Well Name	Well Number	US Well Number	Lease Number	Case Number	Operator
GATO GRANDE 9-	601H	3002551815	NMNM98192	NMNM98192	DEVON
GATO GRANDE 9-	701H	3002551325	NMNM98192	NMNM98192	DEVON
GATO GRANDE 9-	801H	3002551327	NMNM98192	NMNM98192	DEVON

Notice of Intent

Type of Action: Variance

Procedure Description: Devon Energy Production Co., L.P. (Devon) respectfully requests a variance to break test. Please see attachment.

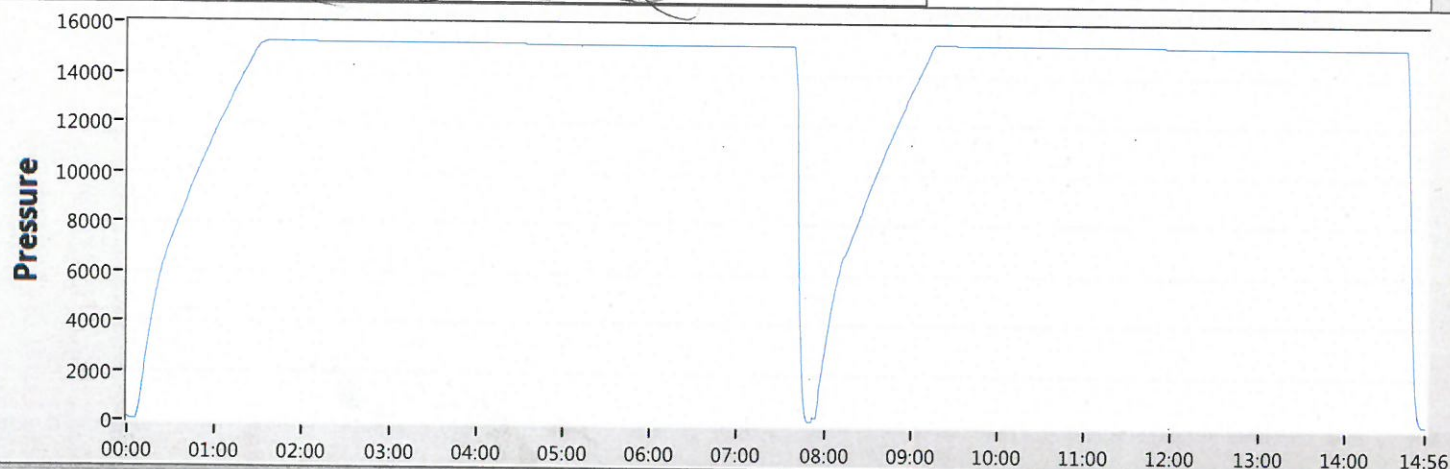
Devon Energy requests to only test BOP connection breaks after drilling out of surface casing and while skidding between wells which conforms to API Standard 53 and industry standards. This test will include the Top Pipe Rams, HCR, Kill Line Check Valve, QDC (quick disconnect to wellhead) and Shell of the 10M BOPE to 5M for 10 minutes. If a break to the flex hose that runs to the choke manifold is required due to repositioning from a skid, the HCR will remain open during the shell test to include that additional break. The variance only pertains to intermediate hole-sections and no deeper than the Bone Springs Formation where 5M BOP tests are required. The initial BOP test will follow OOGO2.III.A.2.i, and subsequent tests following a skid will only test connections that are broken. The annular preventer will be tested to 100% working pressure. This variance will meet or exceed OOGO2.III.A.2.i per the following: Devon Energy will perform a full BOP test per OOGO2.III.A.2.i before drilling out of the intermediate casing string(s) and starting the production hole, before starting any hole section that requires a 10M test, before the expiration of the allotted 14-days for 5M intermediate batch drilling or when the drilling rig is fully mobilized to a new well pad, whichever is sooner. We will utilize a 200' TVD tolerance between intermediate shoes as the cutoff for a full BOP test. The BLM will be contacted 4hrs prior to a BOPE test. The BLM will be notified if and when a well control event is encountered. Break test will be a 14 day interval and not a 30 day full BOPE test interval. If in the event break testing is not utilized, then a full BOPE test would be conducted.

1. Well Control Response:
 1. Primary barrier remains fluid
 2. In the event of an influx due to being underbalanced and after a realized gain or flow, the order of closing BOPE is as follows:
 - a) Annular first
 - b) If annular were to not hold, Upper pipe rams second (which were tested on the skid BOP test)
 - c) If the Upper Pipe Rams were to not hold, Lower Pipe Rams would be third

All Previous COAs Still Apply. Variance request procedure is approved as written, please see below general conditions for variance.

- **BOPE Break Testing is ONLY permitted for 5M BOPE or less. (Annular preventer must be tested to a minimum of 70% of BOPE working pressure and shall be higher than the MASP)**

- **BOPE Break Testing is NOT permitted to drilling the production hole section.**
- **Variance only pertains to the intermediate hole-sections and no deeper than the Bone Springs formation.**
